## CD Submittal #3 – Comment Response

### Environmental Comments:

2. Site development plan sheet 12

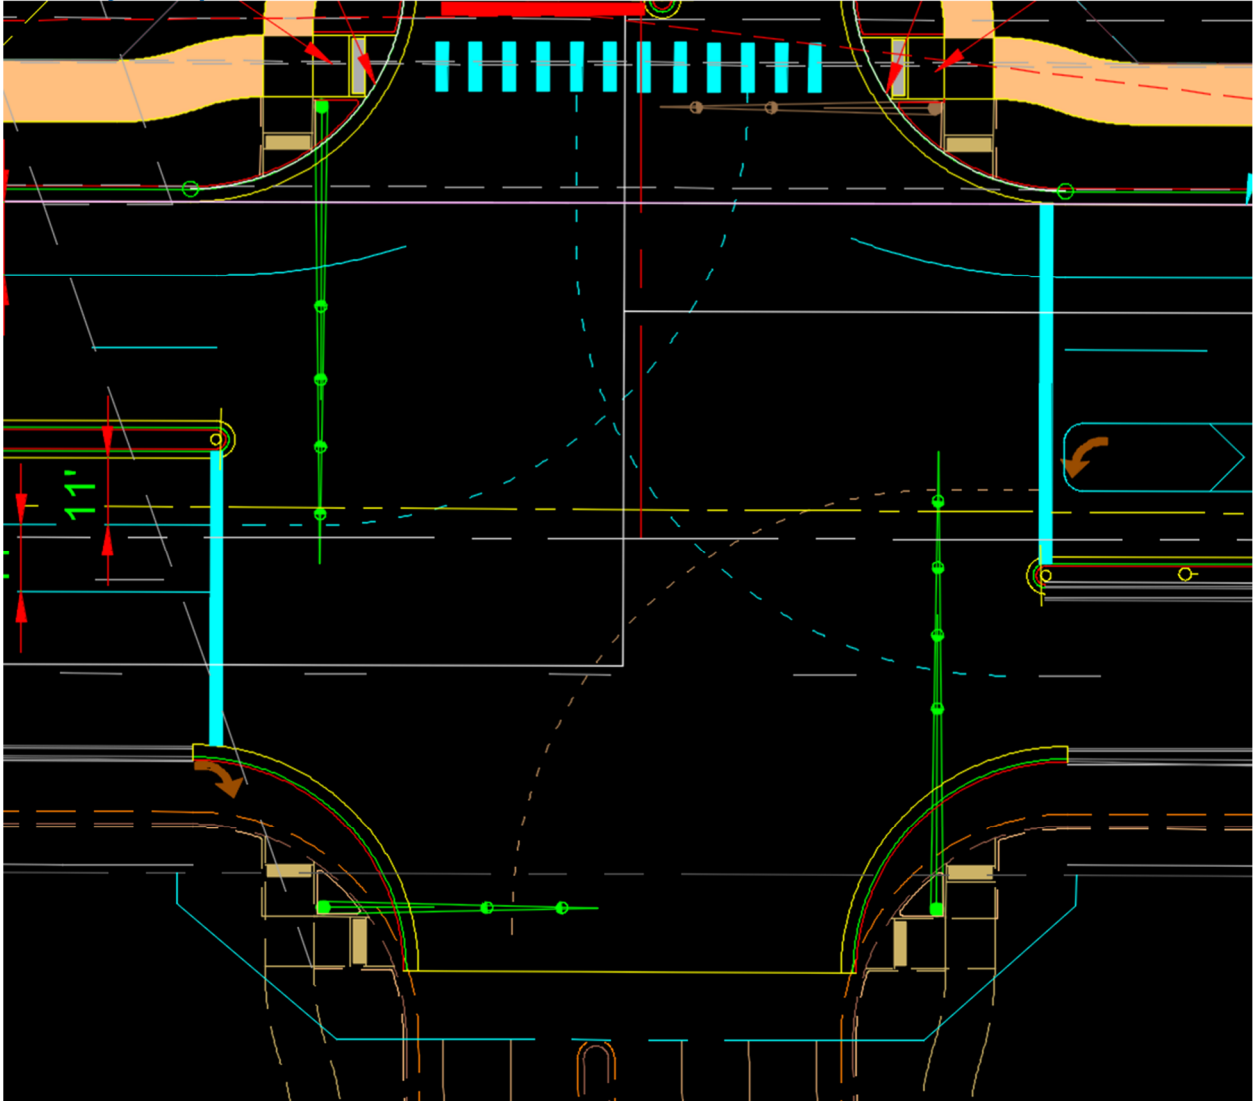
The WB to SB le turn lane is labelled as 11 wide, but that may include the theoretical 1 shoulder/gutter, making it a 10 lane. How far is traffic from the edge of any median posted signs?

**Response: The widths provided are from stripe to edge of pavement. The turn lane has 11' of asphalt. The signs post will be 3.5-feet from the edge of pavement.**

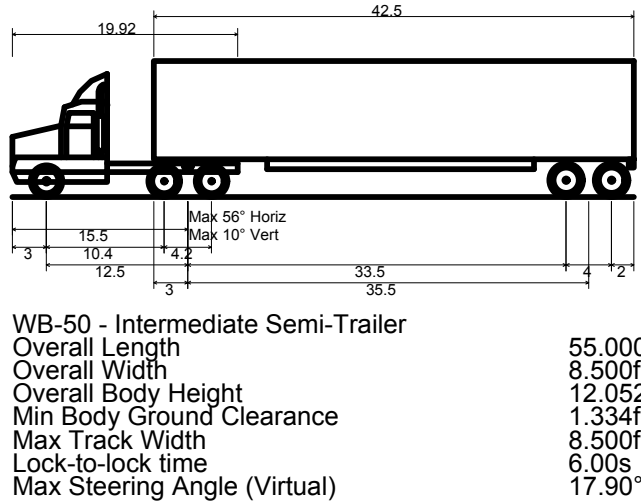
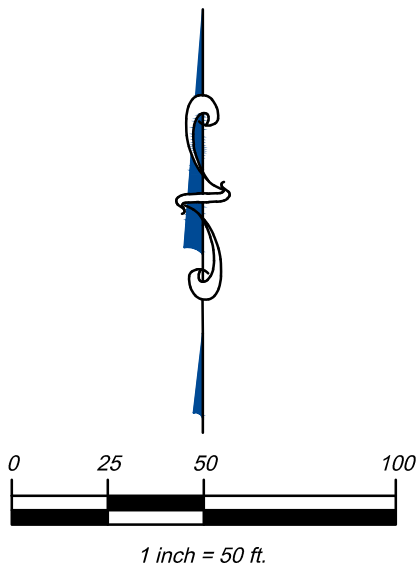
10/21/2025: the applicant should document that primary WQ treatment for CDOT ROW will not be provided in the drainage report or memo of some kind and submitted.

**Response: A note has been added to the drainage report and is included as the second to last page of this comment response letter.**
